# BULLETIN D'INFORMATION PRODUIT

BIP 21-003

## Découpe des rails pour modules 1750 (ASNE0597) et mise en conformité Reach/Rohs

*Mounting rail cutting for 1750 modules (ASNE0597)  
And Reach/Rohs compliance*

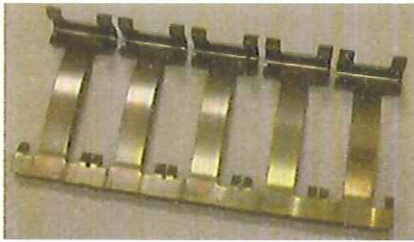
**DECOUPE :** Avec notre sous-traitant historique, la protection des supports se faisait après découpe de ceux-ci.

**Pour des raisons de sécurisation de sous-traitance et réactivité sur nos délais, la découpe des supports se fait dans le rail protégé de 2mètres.**

*CUTTING: With our historical subcontractor, the plating of the supports was done after cutting.*

*For reasons of security of subcontracting and reactivity on our deadlines, the cutting of the supports is done in the plated rail of 2m*

**DECOUPE :** Inchangées. Conforme à l'AIPS 07-05-005.

*CUTTING: Unchanged. In accordance with AIPS 07-05-005.*

**CONFORMITE REACH / ROHS / REACH / ROHS CONFORMITY**

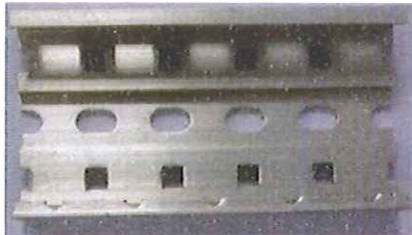
**CONFORMITE REACH / ROHS: Pour les rails : remplacement de l'oxydation anodique sulfurique bichromatée par oxydation anodique sulfurique avec colmatage sels de Nickel  
Pour les ressorts : remplacement du cadmium passivé Cr6 par Zinc passivé Cr3**

*REACH / ROHS CONFORMITY: For the rails: replacement of dichromated sulphuric anodic oxidation by sulphuric anodic oxidation with clogging by Nickel salts*

*For the springs: replacement of cadmium with Cr6 passivation by Zinc with Cr3 passivation*

**CONFORMITE REACH / ROHS: Inchangées. Ces substituts sont compatibles de l'ancienne version.**

*REACH / ROHS CONFORMITY: Unchanged. These substitutes are compatibles with the old version.*
